Docket No. 50-255

Change No. 9
License No. DPR-20

4.12 AUGMENTED INSERVICE INSPECTION PROGRAM FOR HIGH ENERGY LINES
OUTSIDE OF CONTAINMENT

FIGURE
4.12 A

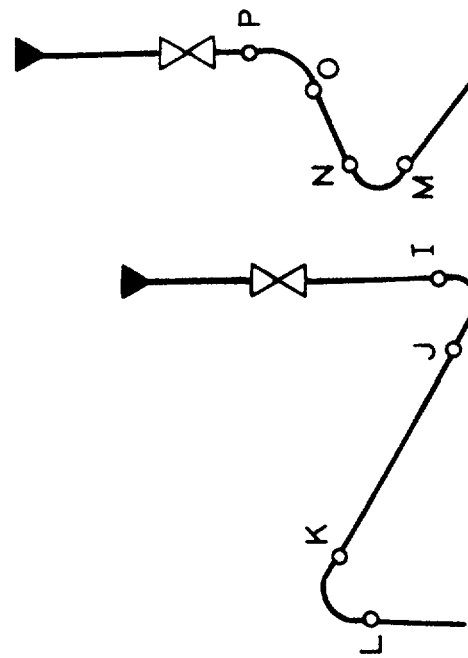
- 4.12.1 For welds identified in Figure 4.12.A (Main Steam Lines) and Figure 4.12.B (Feedwater Lines):
- a. At the first outage period, such as refueling, a volumetric examination shall be performed with 100 percent inspection of welds in accordance with the requirements of ASME Section XI Code, "Inservice Inspection of Nuclear Power Plant Components."
 - b. The inservice inspection at each weld shall be performed in accordance with the requirements of ASME Section XI Code, "Inservice Inspection of Nuclear Power Plant Components," with the following schedule (the inspection intervals identified below sequentially follow the baseline examination of 4.12.1.a above):

4.12.2 For other welds (excluding those identified in Figure 4.12.A and Figure 4.12.B):
